The following addendum supersedes information contained in drawings and specifications issued for the project to the extent referenced. This Addendum forms part of the Tender Documents and is subject to all of the conditions set out in the contract conditions.

END OF MECHANICAL ADDENDUM NO. 4

PROJECT TITLE
DASHWOOD FIRE HALL REPLACEMENT

UNIT HEATER (ELECTRIC)

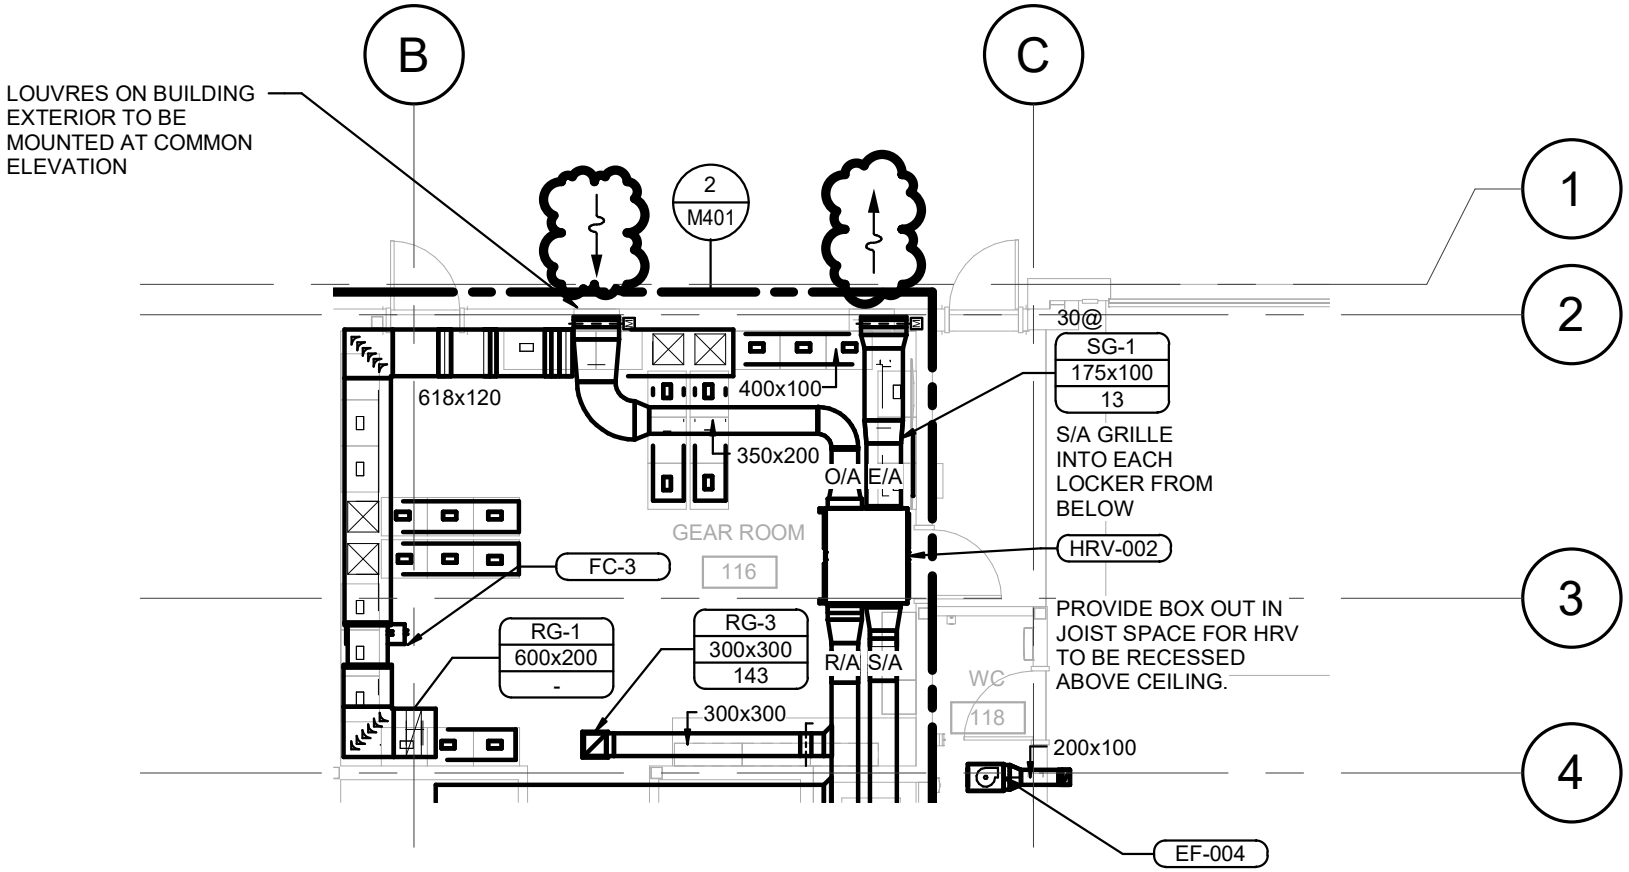
.2 **M001 Indicates that the Unit Heaters are supplied by Mechanical. No schedule has been provided for these units, please advise.**

.6 **M001 indicates that the FFH are to be supplied by the mechanical trade, no schedule is provided. Please confirm this is correct.**

.1 Add: Unit Heater (Electric) schedule

.2 Add: Force Flow Heater - Electric schedule

.1 Response: Refer to attached UH schedule.

.1 Response: Refer to attached FFH schedule.

.1 Refer to attached Unit Heater (Electric) schedule for UH-001 through UH-004 specification

.1 Refer to attached Force Flow Heater - Electric schedule for FFH-1 and FFH-2 specification.

DRAWING TITLE
HRV-002 REVISED AIR STREAMS

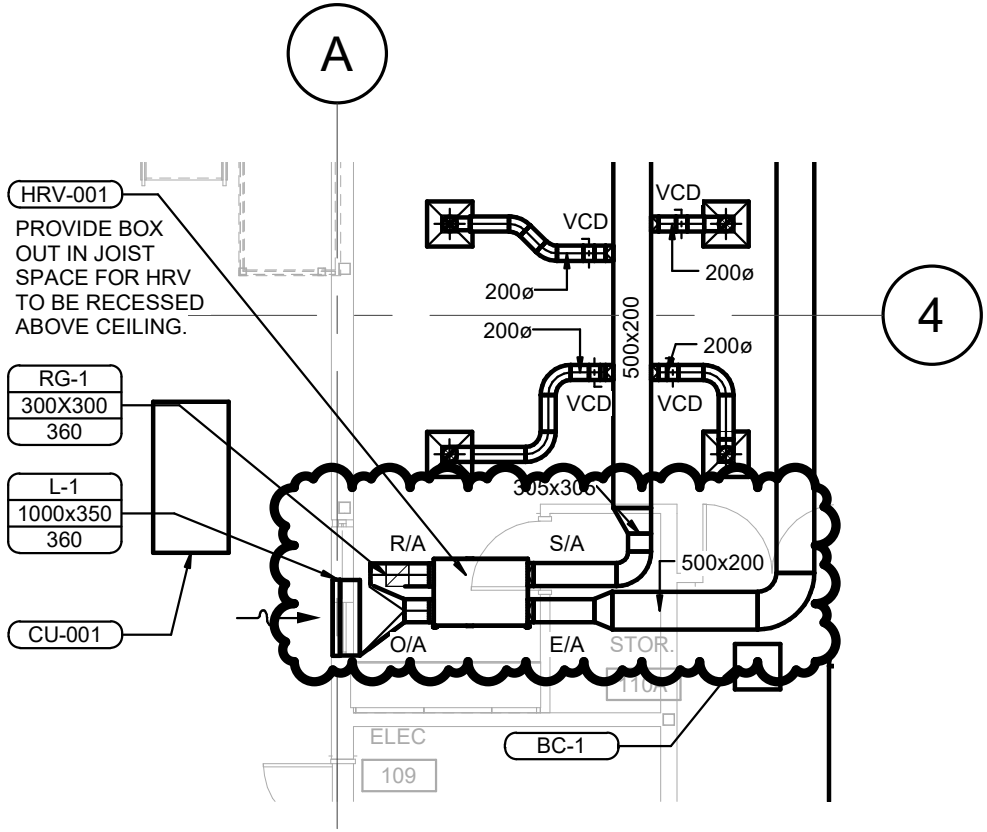
.2 HRV-2 to be model HE-1XJINV. E/A and O/A louver locations to be swapped to match duct connections of updated model. Refer to attached sketch.
